SEWAGE DISPOSAL TESTING

MARYLAND STATE DEPARTMENT OF HEALTH

PROPERTY OWNER BEN WHITEHURST

**PLAT OF SURVEY  
 FOR  
 BEN WHITEHURST  
 FIFTH ELECTION DISTRICT OF HOWARD COUNTY  
 DAYTON, MARYLAND  
 SCALE: 1 IN. = 100 FT. MARCH 15, 1965**

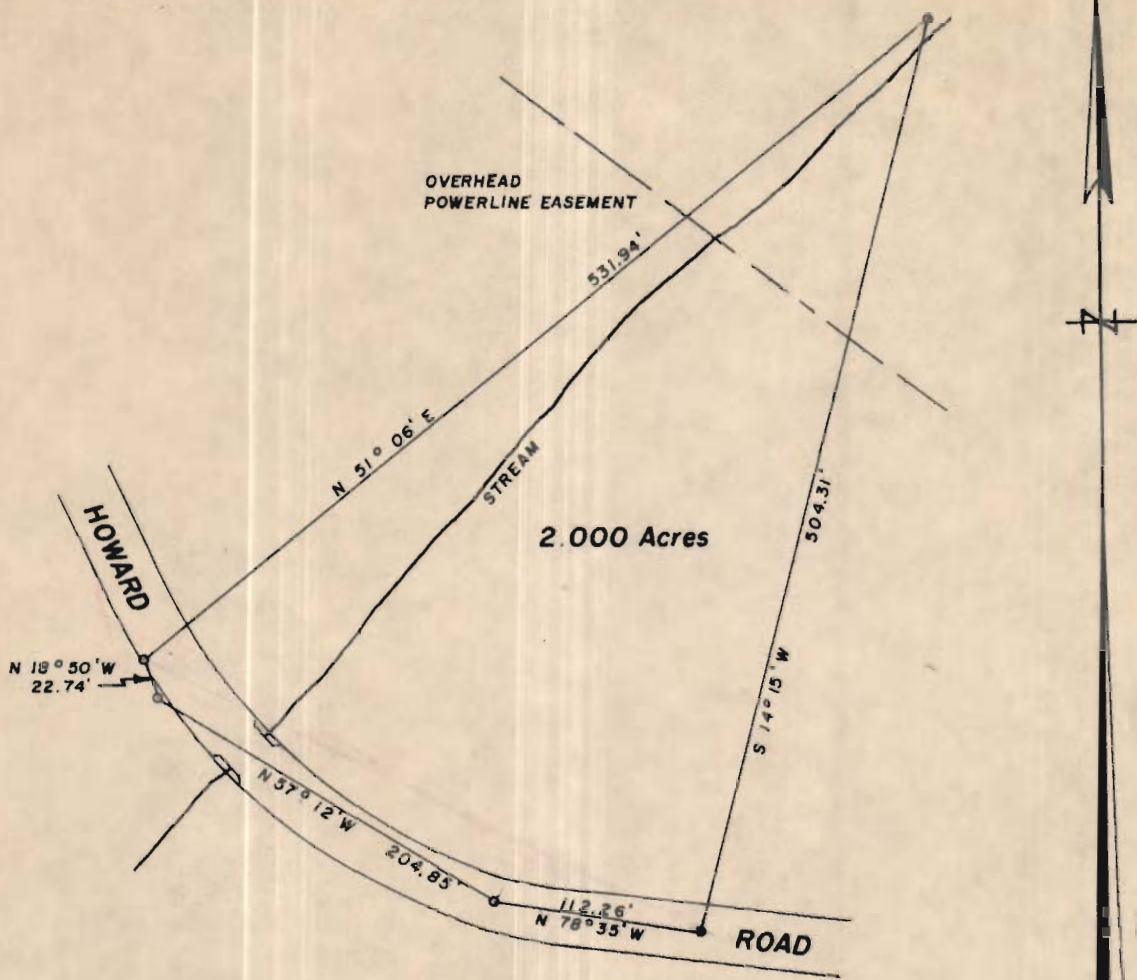
REASONS FOR REJECTION OR HOLDING 6-7-66 High water table on highest part of lot. Even if pipe were possible in this area system could not be installed above water supply. J.H.

DATE	TEST NO.	DEPTH	PRE-WET		TEST - 1" DROP		TIME
			START	STOP	START	STOP	
6-7-66	1	7 1/2'	Water	gushing in hole	at 4 FT.		
1	2	8'	Water	at 8 ft. on highest point of lot
